ENGINE - INTERMEDIATE STRUCTURE - REWORK THE FAN FRAME ASSEMBLY TO INCLUDE FILLER COMPOUND IN THE REAR INNER FLANGE AREA - CATEGORY CODE 3 - MOD.ENG-72-0009

V2500-ENG-72-0009

SERVICE BULLETIN

Modification of the fan frame assembly
Fig.3(Sheet 1 of 5)

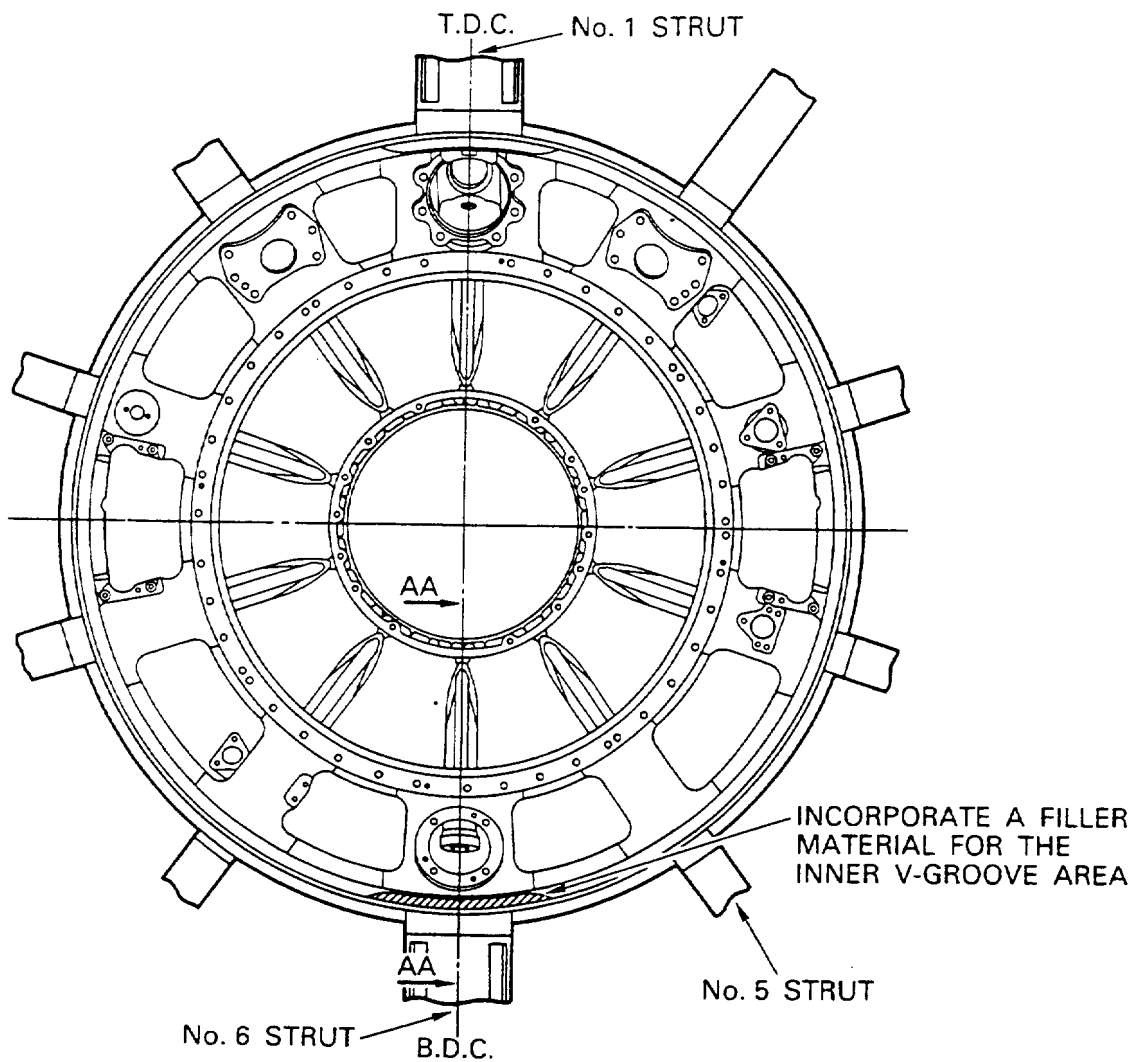
Procedure	Supplementary Information
(1) Find the filling area	Refer to Figure 3, Sheet 1.
(2) Clean the specified area	Use a clean white lint free cloth made moist with CoMat 01-031 acetone or CoMat 01-060 acetone or CoMat 01-076 methylethylketone or CoMat 01-124 isopropyl alcohol.

(a) The filler material (CoMat 08-006 Two-pack filler - Spec No. J-MSRR 9152 Two part epoxy low density void filling compound) is applied to the Fan Frame rear V-groove in the specified area.

Modification of the fan frame assembly
Fig.3(Sheet 2 of 5)

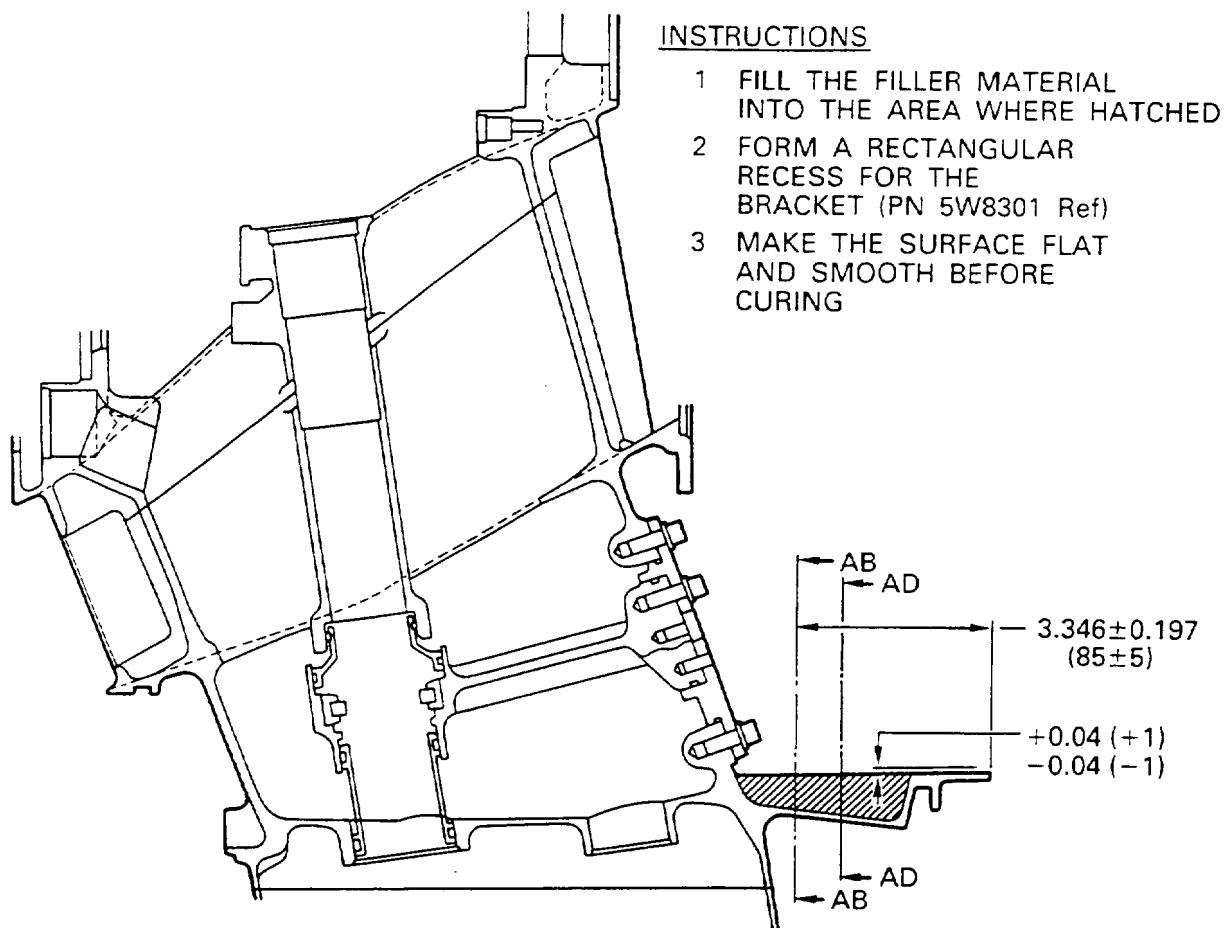
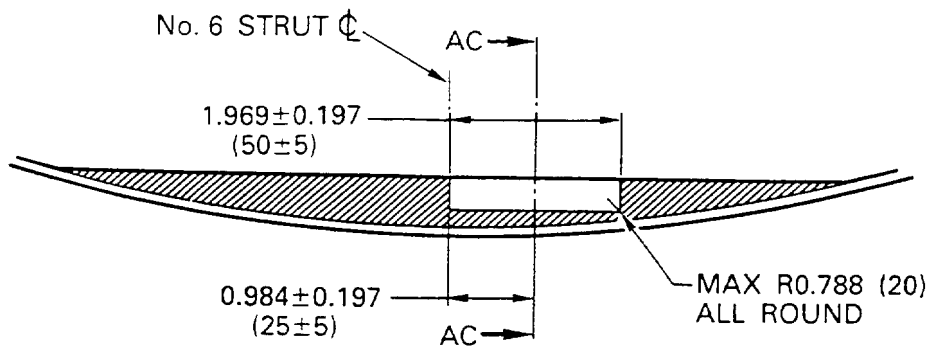
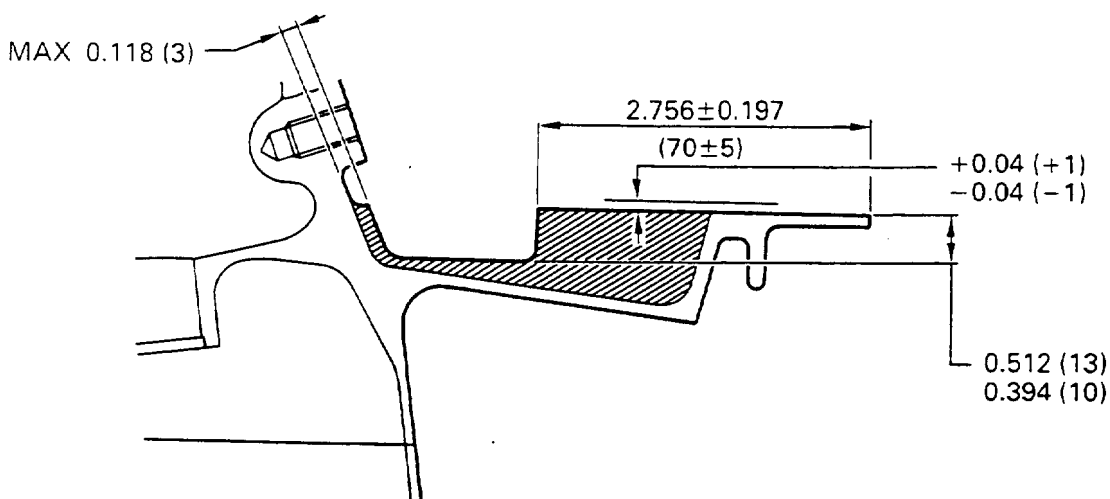
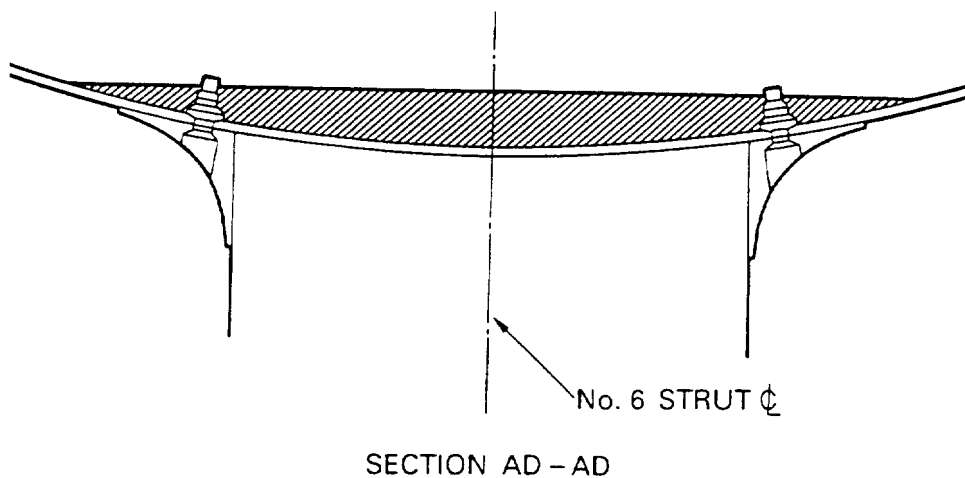
(5) Fill the specified area and form a rectangular recess for 5W8301, Bracket by finger. Allow slight overfilling for trimming. Refer to Figure 3, Sheets 2 to 5.

(6) Trim the excess filler material flush and make the surface flat and smooth before curing. Use spatula or equivalent.

Identification of new part number
Fig.4

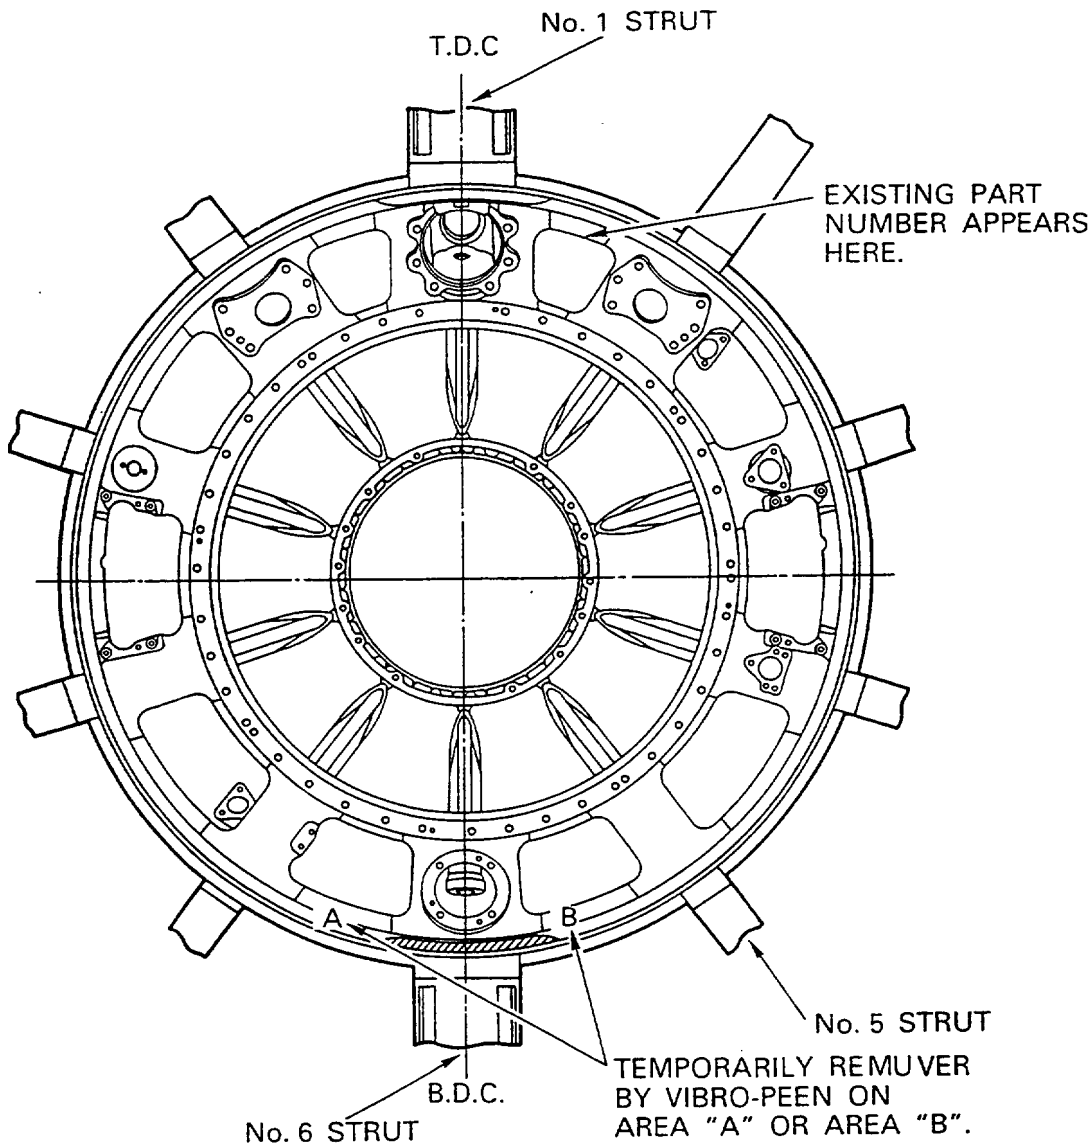
(8) Temporarily renumber by the vibro-peen on the surface of the Fan Frame near the filler area at the bottom strut. Refer to Figure 4.

Existing	Renumber
5A0256	5A0362
5A0230	5A0363
5A6592	5A0364
5A6596	5A0365
5A0267	5A0366

NOTE: These new part numbers will be transferred adjacent to the existing part numbers at next shop visit by a Service Bulletin or other instructions to be issued later.
